Re: Subject: Geotechnical Review and Recommendations
Project Name: Fyffe Avenue Grade Separation
Project Address: Port of Stockton
Stockton, California
Terracon Project Number: NA205020

Our office was requested to review and offer a second opinion regarding geotechnical and foundation recommendations for the subject project. Existing recommendations are contained in the recently completed *Draft Foundation Report Fyffe Avenue Overcrossing Over UPRR Railroad* prepared by Twining, dated January 30, 2020, Project No. 190892.5. This request was made due to the presence on our staff of senior geotechnical engineer, Mr. Ron Heinzen, formerly with Kleinfelder's Stockton office. Mr. Heinzen has a long history and extensive experience with soil conditions and foundation construction practices at the Port of Stockton.

Figure 1, MDT Geotechnical Manual, Earth Retaining Systems, July 2008

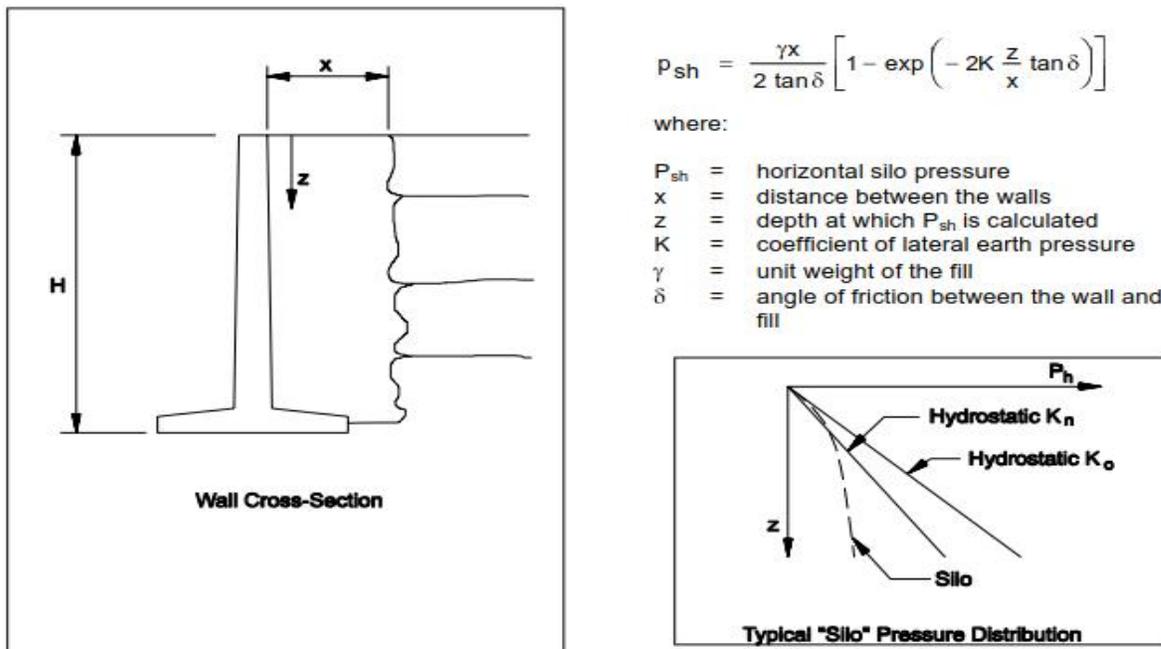
Bridge abutment and wing walls will be a special case of rigid retaining walls since they will be backed by self-supporting abutment fill walls, referred to as Temporary walls (see Section 7.c). The gap between the vertical face of the temporary embankment walls and the rear face of the abutment and wing walls will be backfilled with gravel. This gravel fill, referred to as a "silo" fill, will be the only source of lateral pressure on the walls.

The gap between the two walls will be 2-feet along the wings and 4-feet along the abutments. Estimated height of silo fill on top of the pile cap footing is 41-feet (40' gravel, 1' roadway). We have allowed for an additional 2-feet of height to account for surcharge live load. Gravel backfill should consist of ¾-inch clean washed gravel (ASTM D448, sizes 6, 67, or 68).

Lateral pressure has been computed utilizing the equation published in the Montana Department of Transportation (MDT) Geotechnical Manual, Chapter 17, Earth Retaining Systems (see Figure 1). The following parameters apply:

α_{sh} = horizontal silo pressure	calculated
x = distance between walls	2.0 and 4.0 feet
z = depth at which α_{sh} is calculated, max 43'	43 feet
K = coef. of lateral earth pressure	0.140
Y = unit wt. of backfill	110 pcf
δ = angle of friction between wall/fill, $2/3 \Phi$	32.7
Φ = backfill friction angle	49

Figure 2, Abutment wall Loading Diagram

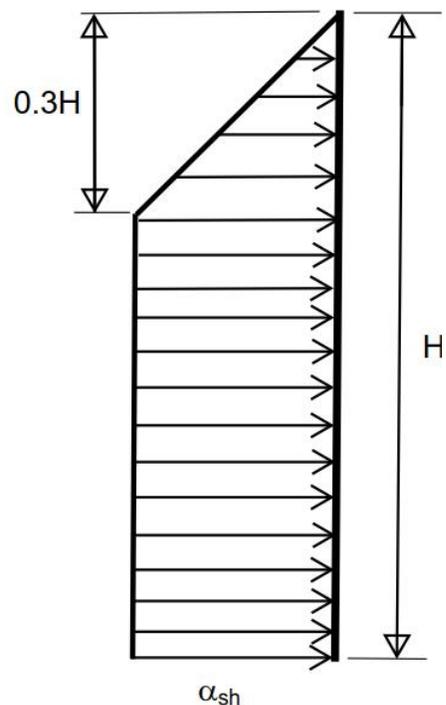
Computed horizontal force produces a roughly trapezoidal loading. Therefore, the lateral loading diagram shown in Figure 2 should be used for the walls along with the values presented in Table 10. To account for surcharge load the top of the diagram should start 2-feet above the top of the roadbed.

Table 10, Lateral Wall Pressure		
Wall	x, Silo Fill Gap, ft.	α_{sh} , Horizontal Silo Fill Pressure, psf
Wing	2.0	170
Abutment	4.0	300

Due to the limited width of silo backfill it is estimated lateral seismic loading from backfill on the abutment wall will be less than the seismic force on the wall from its self-weight, therefore no additional seismic lateral loading from the backfill needs to be considered.

Figure 3, Subsurface Settlement System

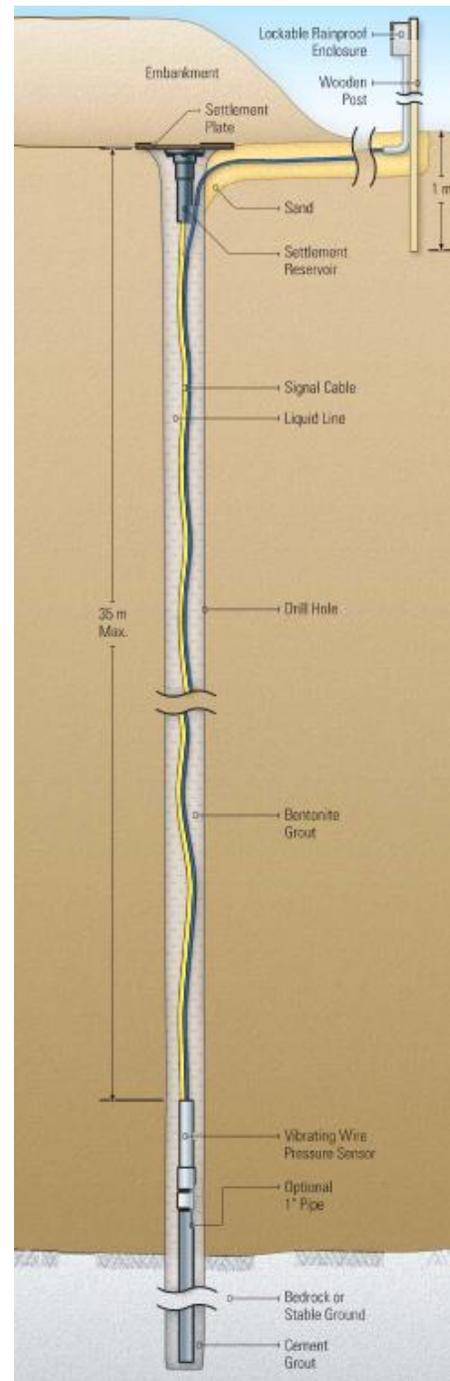
Each vertical sensor array should consist of two vibrating wire piezometers (Geokon, model 4500) and one vibrating wire settlement system (Geokon, model 4600) installed and grouted into vertical bore holes. The settlement system consists of a vibrating wire piezometer, installed below the depth of anticipated settlement, connected by a liquid-filled tube to a reservoir attached to a settlement plate located at the ground surface. As fill is placed, the reservoir settles and the change in liquid pressure on the sensor is recorded. The advantage of this system is it does not provide any hindrance to construction and grading operations, since all components are buried (see Figure 4).

The piezometers to monitor soil pore water pressure should be located at approximately the 8- and 20-foot depths in the bore holes. These depths are subject to field adjustment since it is desired to locate them within underlying clay strata. The settlement piezometer should be located at the 60-foot depth. Once sensors are installed the borehole should be filled with cement/bentonite grout consisting 2.5-part water, 1.0-part cement, and 0.3-part bentonite (by dry weight). Signal cables from all sensors should be buried in trenches excavated below the depth of anticipated subgrade grading and carried to one of two stations located outside the limits of grading operations. One station will need to be on the north side of the RR track and one on the south side. Station location can best be determined by consultation with the general contractor so as to minimize disruption to their work. Each station should consist of a vibrating wire reader/data logger and telemetry with solar recharge to provide real-time hourly readings posted to the Cloud of all sensors.

Figure 4, Instrument Locations

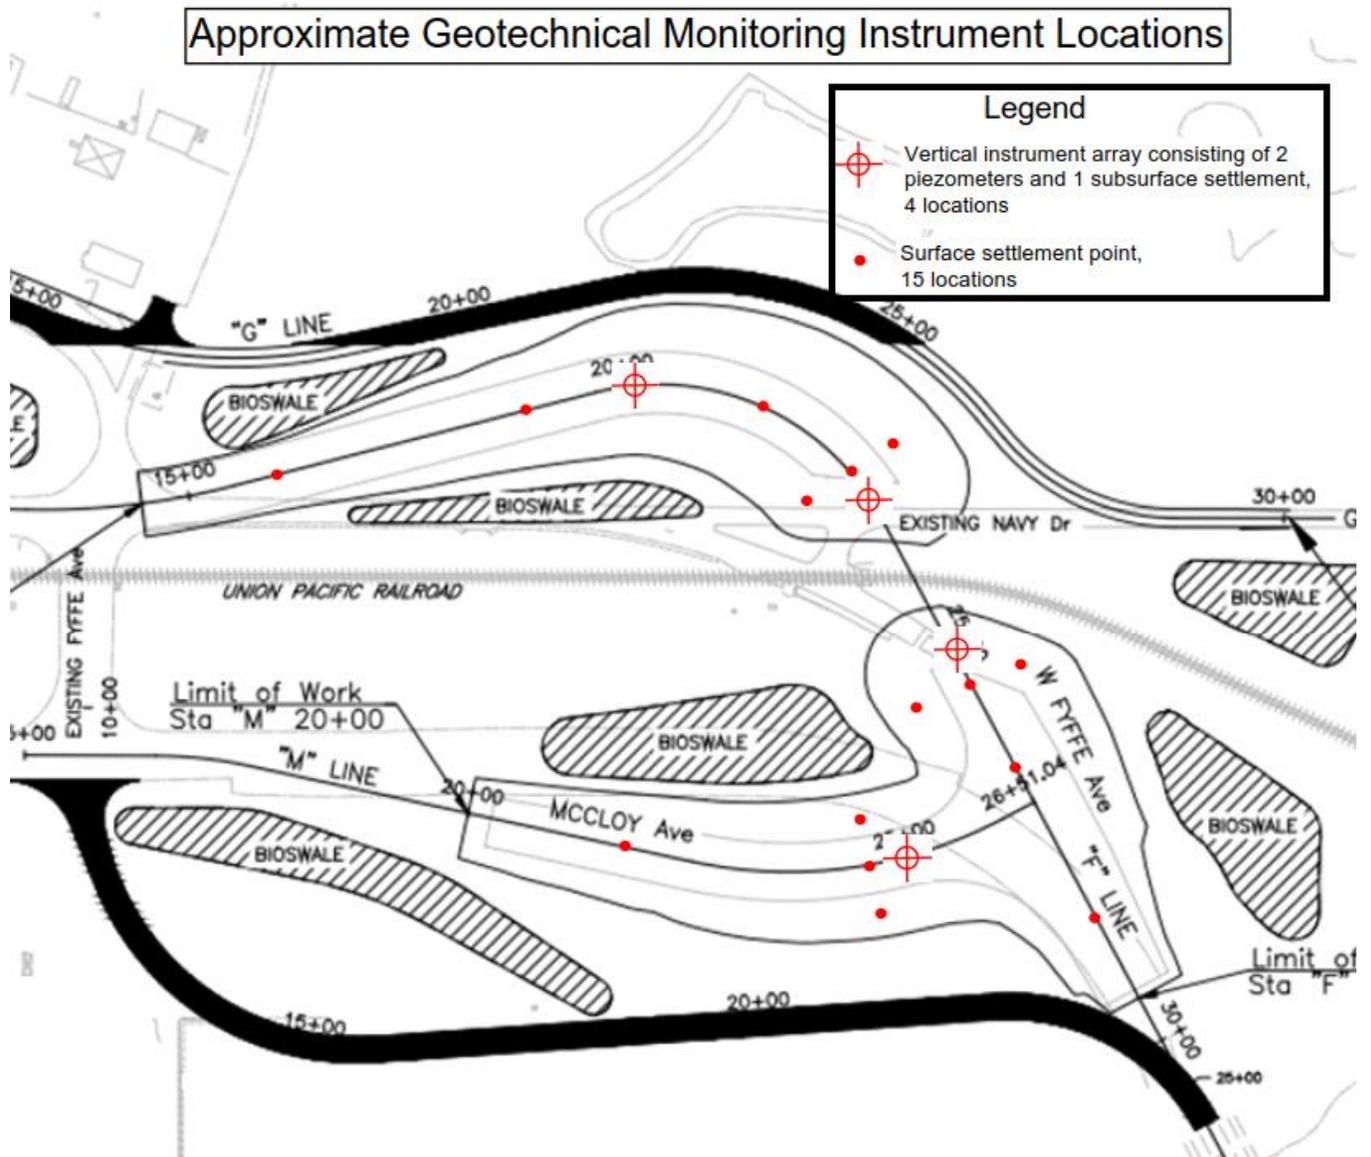
It is recommended 4 vertical sensor arrays be installed in bore holes prior to on-site grading and 15 surface settlement monitoring points installed after Phase I embankment construction is completed. Figure 5 shows approximate instrument locations.

Immediately after Phase I embankment grading is completed surface settlement monitoring points should be installed. Points should consist of a 3-foot length of #4 rebar driven into the fill with 2-inches protruding. If there is the chance on-going construction activity will disturb them, they should be driven to 3-inches below grade and protected with at-grade Christy boxes. Elevations of each point should be surveyed immediately after installation, every three days for the first two weeks, and weekly after that until movement has stabilized. It is anticipated the weekly readings would extend for 2 months.
